Manual Supplement

Manual Title:	1523, 1524 Technical Guide	Supplement Issue:	**3**
Print Date:	March 2014	Issue Date:	11/25
Revision/Date:		Page Count:	2

On page 27, replace Figure 16 with:

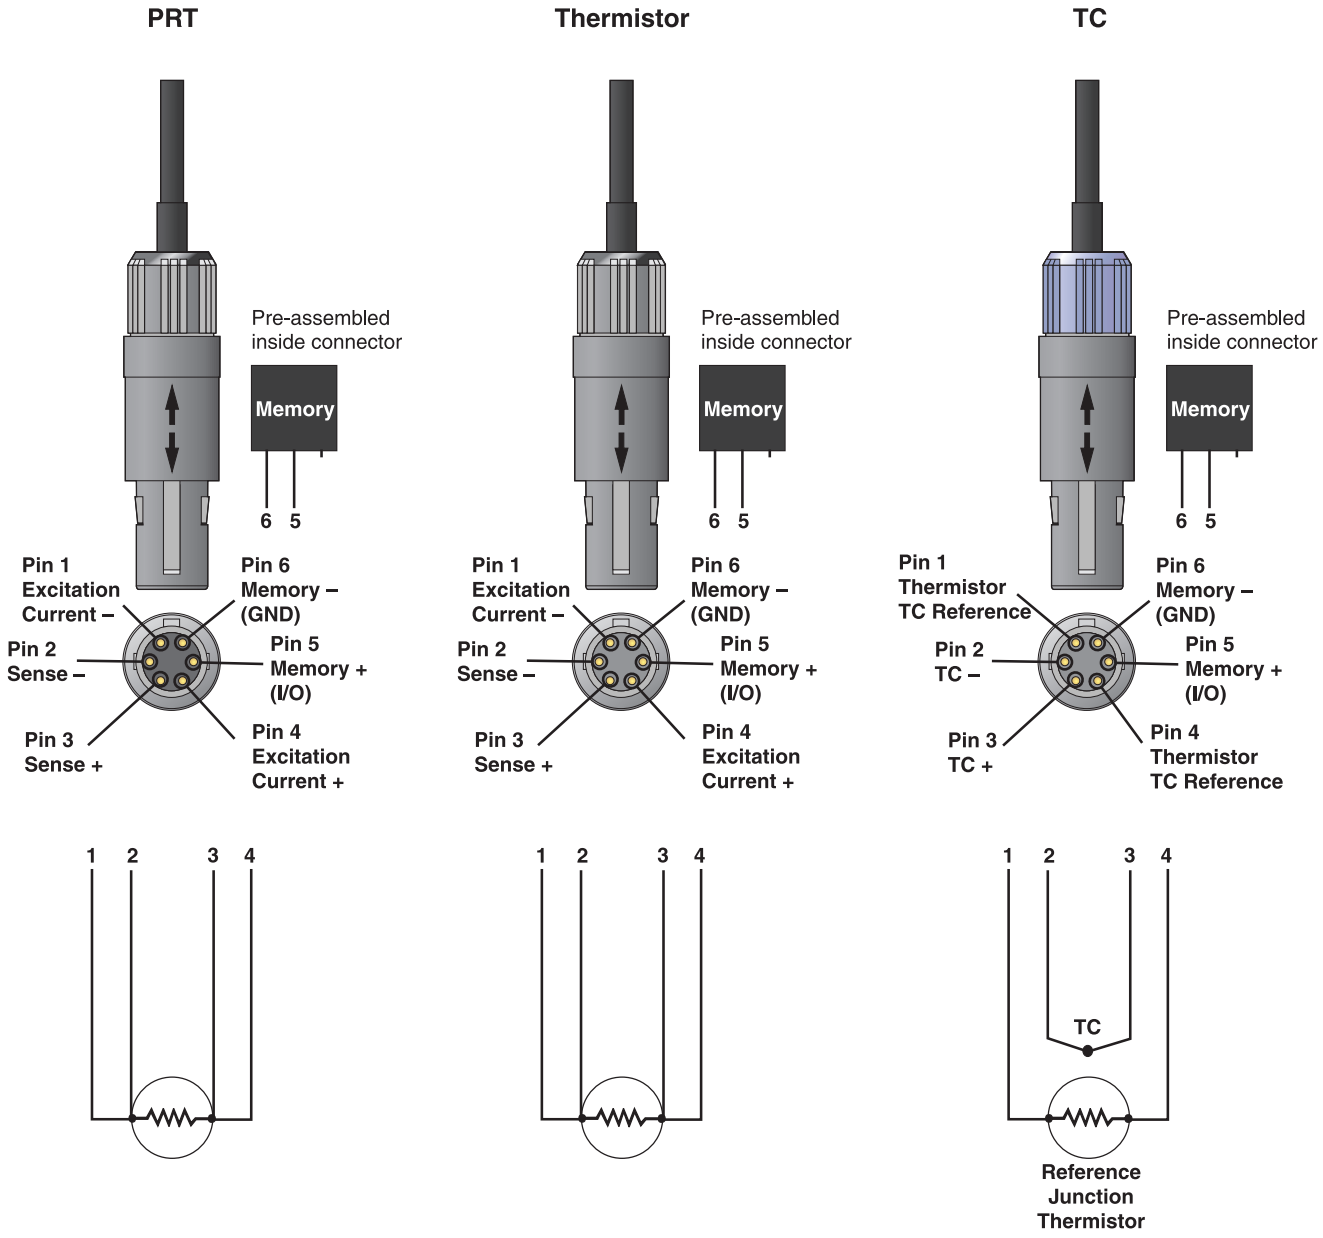
Change #2, 554
